Level RO Tier 1 Group 1 K/A# 055 2.2.25 Imp. RO 2.5 Imp. SRO 3.7

12. The coping study that was done to support the analysis for a loss of all AC power event at Prairie Island took credit for the condensate storage tanks (CSTs). The minimum volume of water in the CSTs ensures the affected unit can be...
- a. placed in MODE 5 within 20 hours.
  - b. maintained in HOT STANDBY for at least 36 hours.
  - c. maintained in HOT SHUTDOWN for at least 36 hours.
  - d. placed in MODE 4 within 20 hours.

**Recommend RO Question #12 be deleted from the examination.**

CONDENSATE SYSTEM  
 FLOW DIAGRAM  
 CONDENSATE SYSTEM

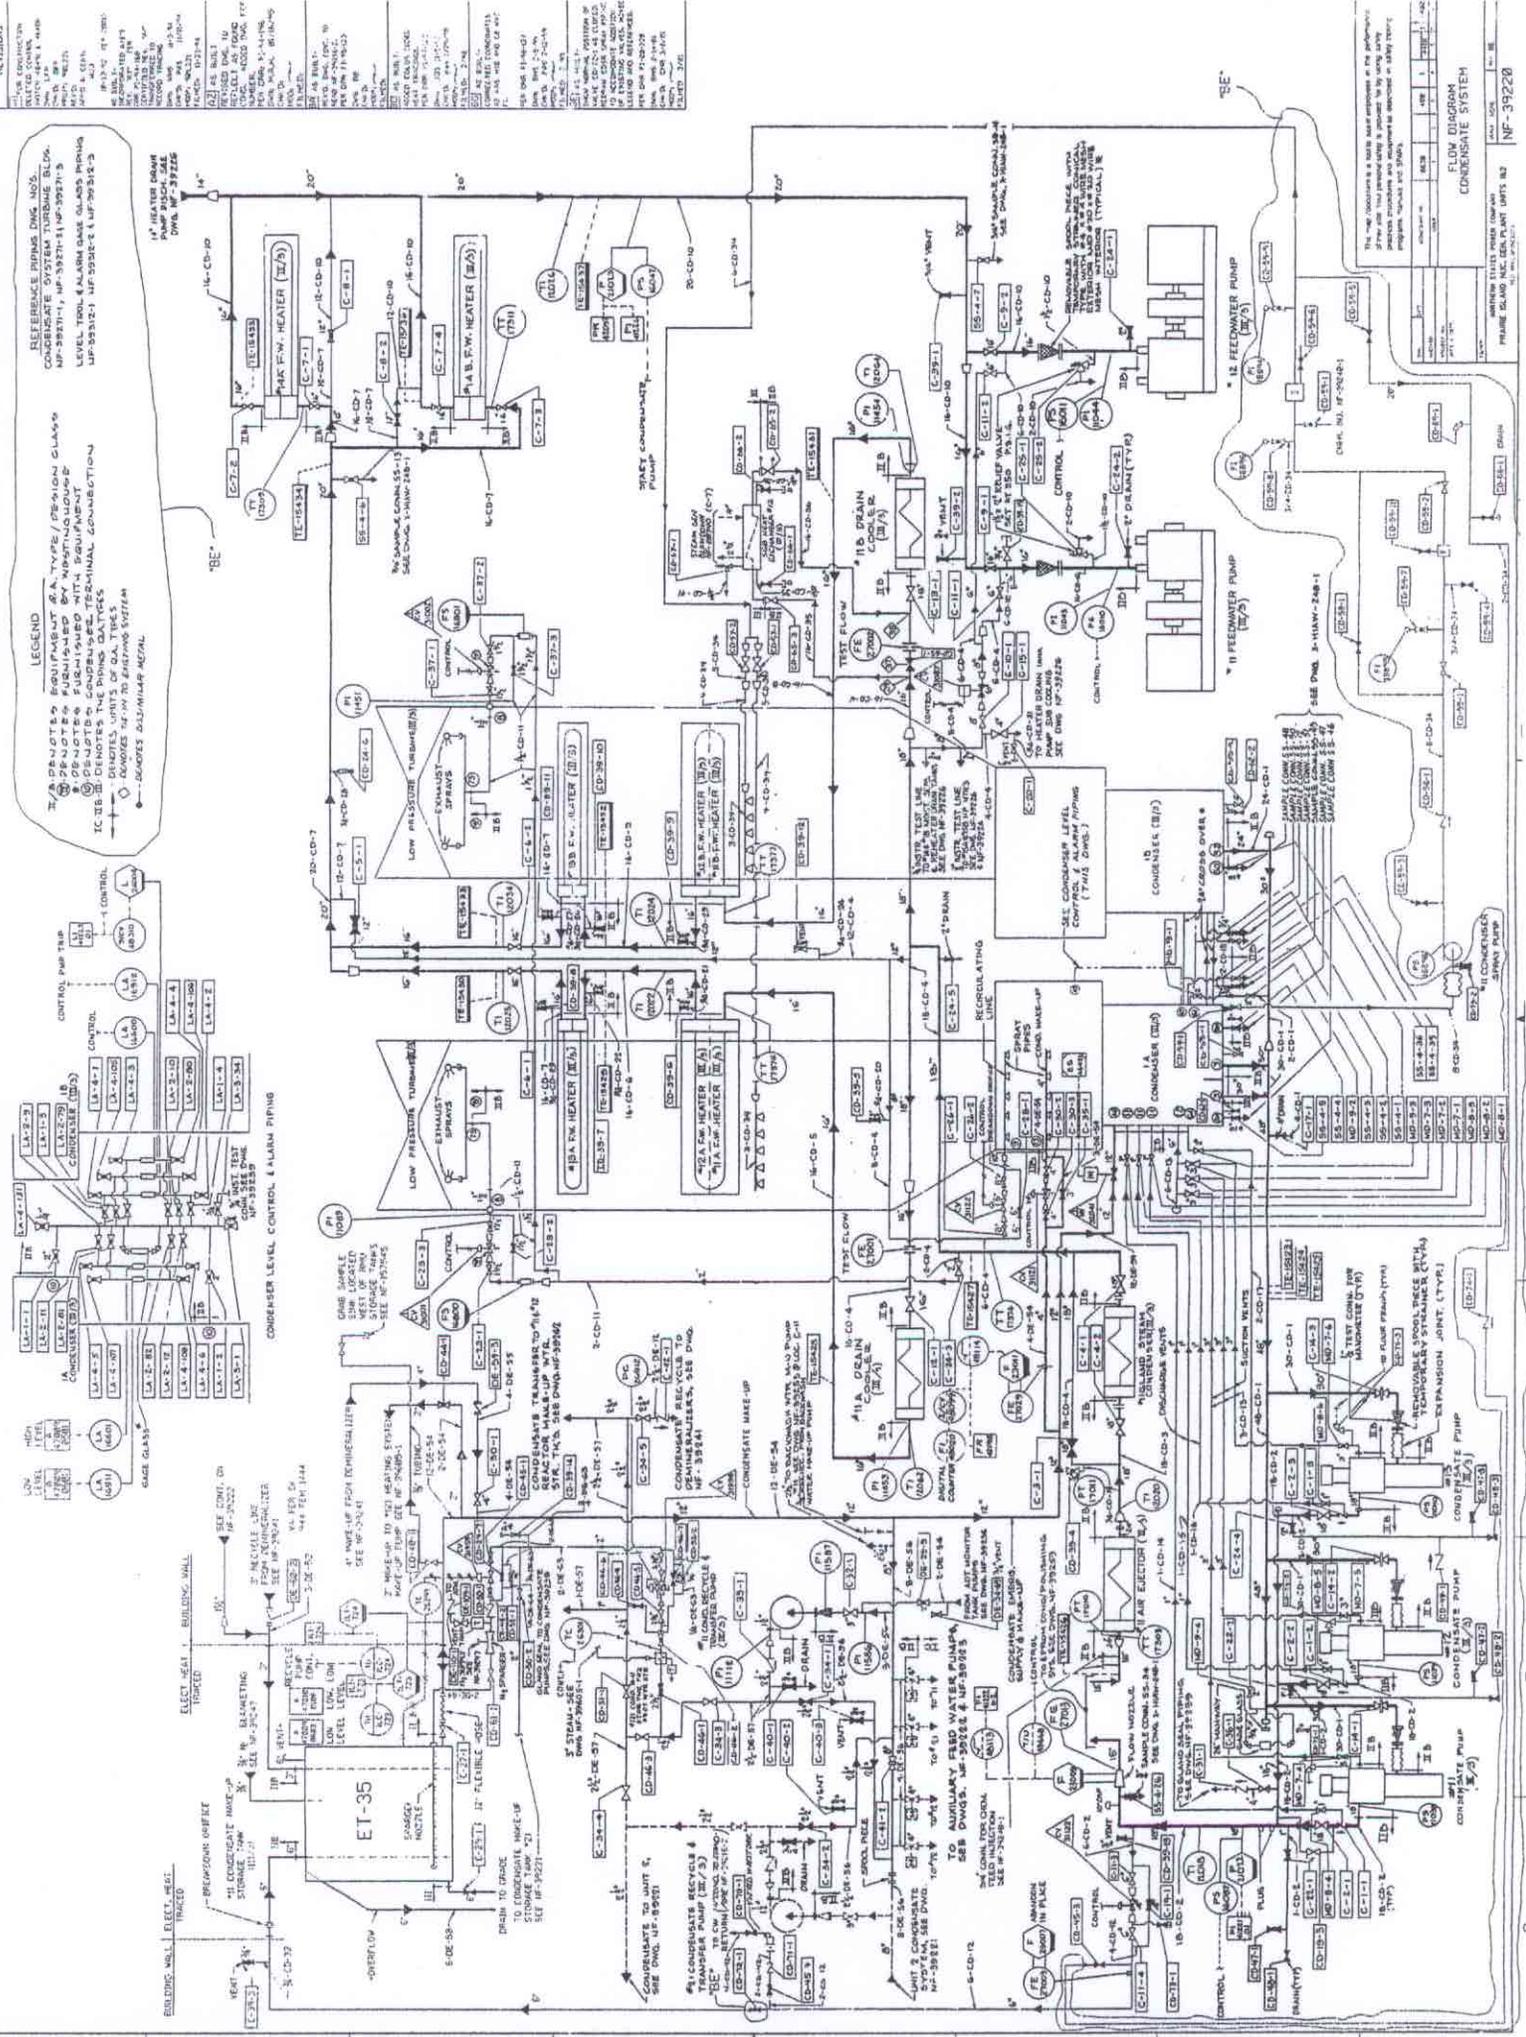
The exam question refers to CSTs (plural) and affected unit (singular). The normal plant configuration for Prairie Island (PI) has the Condensate Storage Tanks (CSTs) crosstied via valve C-41-2. We ensure this valve is maintained open by placing a Safeguards Hold card on the valve in accordance with SWI O-3, "Safeguards Hold Cards & Component Blocking or Locking."

This normal alignment provides a minimum of 200,000 gallons to a single affected unit. This is double the water discussed to in the LCO basis. Since the answer was based on the LCO basis and the question stem establishes conditions that are different, there is no correct answer for RO Question #21.
